**HISTORIC LANDMARK COMMISSION**  
**DEMOLITION AND RELOCATION PERMITS**  
**MAY 24, 2021**  
**SP-2021-065153; GF-2021-068010**  
**FIRE STATION #3**  
**201 W. 30<sup>TH</sup> ST.**

Partially demolish a 1956 fire station and construct a new apparatus bay.

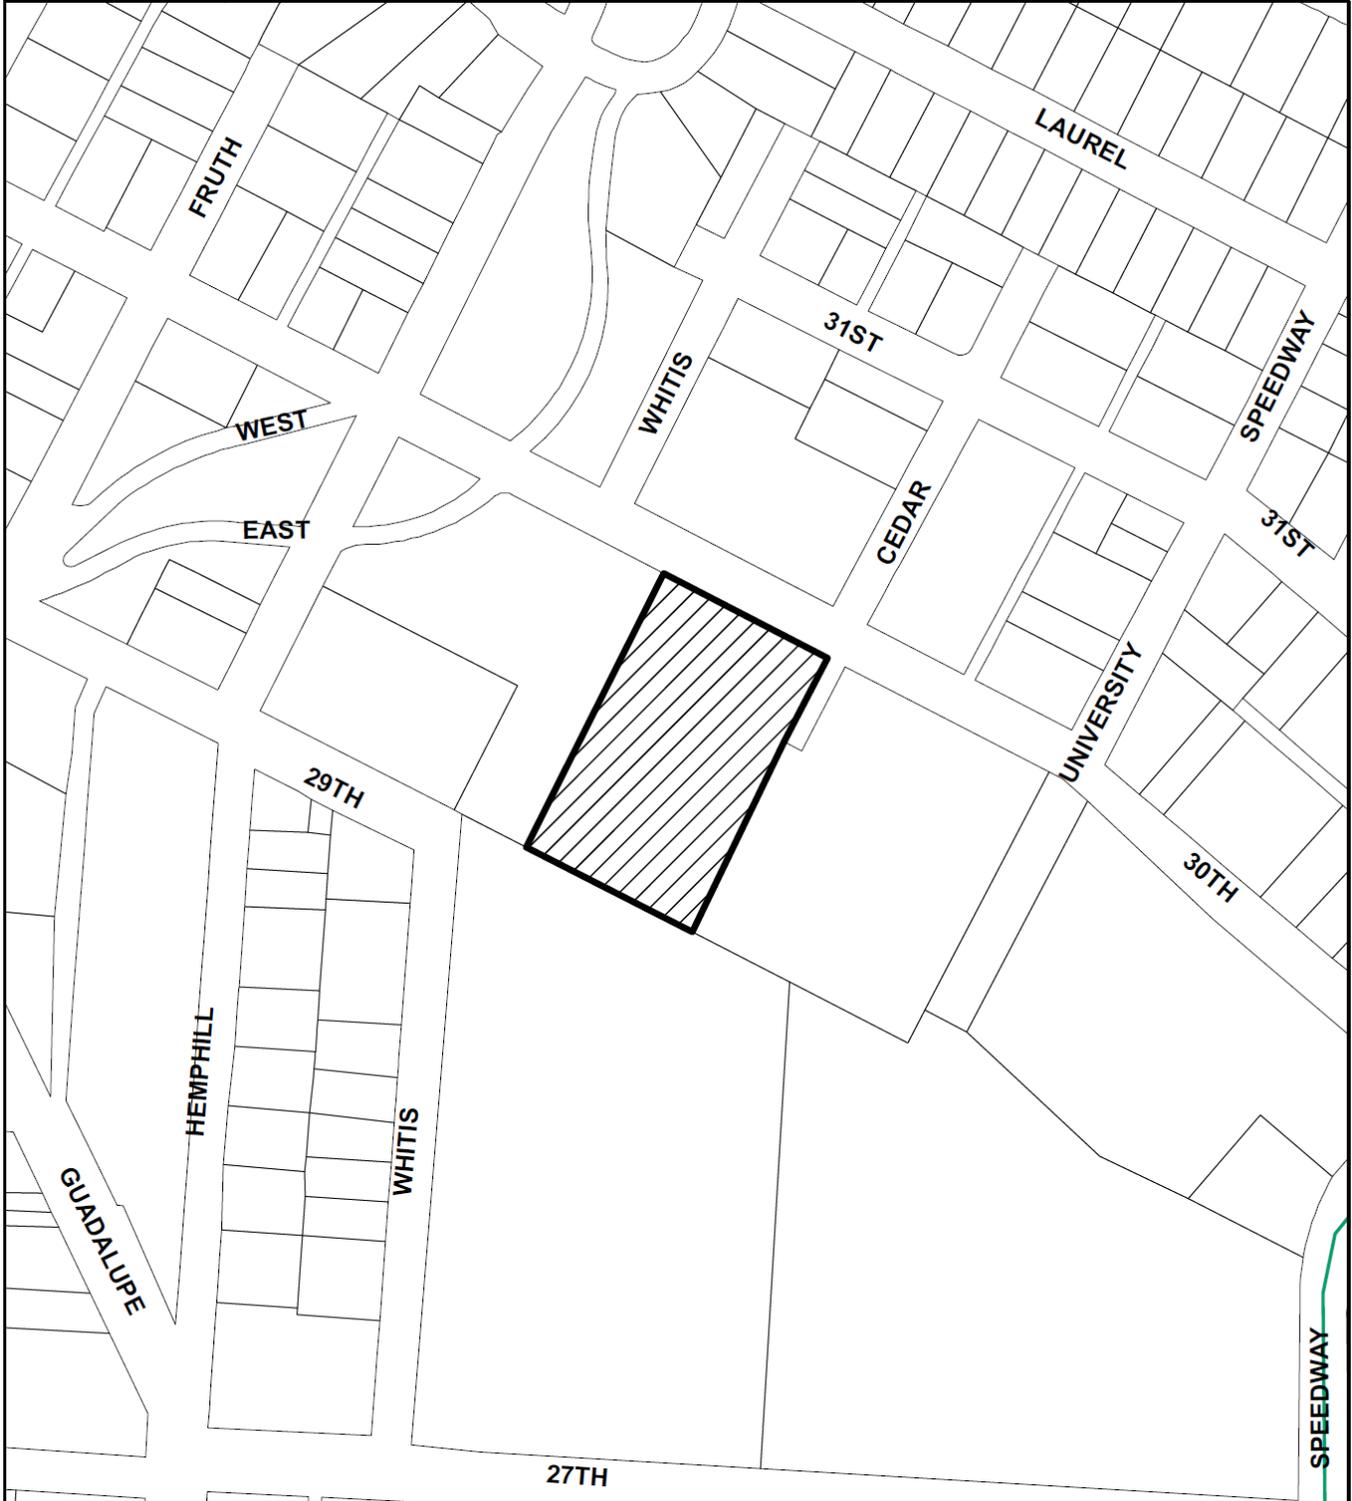
On April 12, 2021, members of the Architectural Review Committee meeting asked about alternatives to demolition and replacement of the apparatus bay. Committee members asked whether it would be possible to modify the existing apparatus bay to meet modern structural and functional requirements. A suggested alternative was to construct an addition rather than replacing the bay in place; the architect indicated there is not adequate developable land due to the width of the site and adjacent 100-year floodplain. While the committee found the design for new construction to be in keeping with the original character, they indicated it would be difficult to move forward with landmark designation after removing such a prominent and significant element of the building.

Release the permit upon completion of a City of Austin Documentation Package.
